Proposal Request

PROPOSAL REQUEST 106

RFI #560 Level 1 Med Gas Pipe Routing Through Curtainwall

PROJECT: AWSOM
BENTONVILLE, AR

Contents:
PLUMBING - ROOF PLAN - AREA A

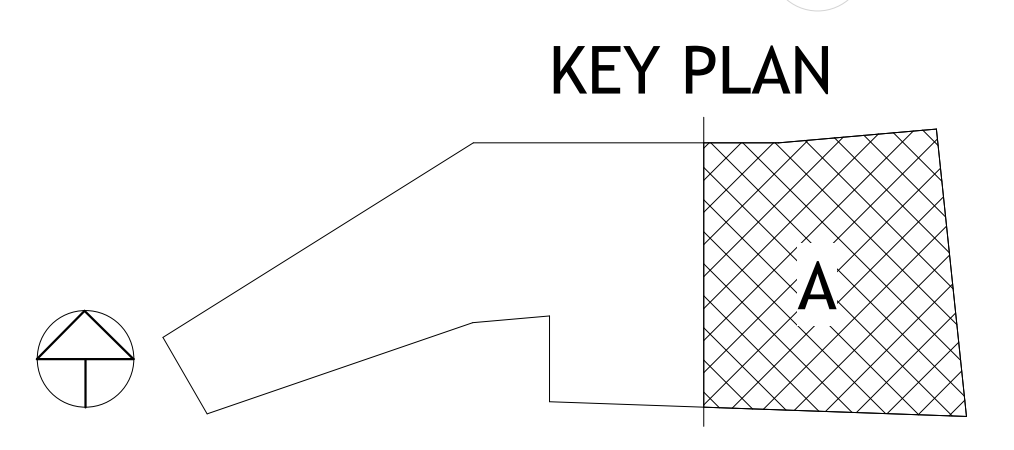
- 1) **PLUMBING**
 - a) Revised Sheet **P105A**
 - ADD 3" SIM AI PIPE.
 - b) Revised Sheet **P300A**
 - REVISE 3" SIM VE PIPE ROUTE.
 - c) Revised Sheet **P301A**
 - REMOVE 3" SIM VE PIPE.
 - REVISE 3" SIM AI PIPE ROUTE.
 - d) Revised Sheet **P302A**
 - ADD 3" SIM AI PIPE.
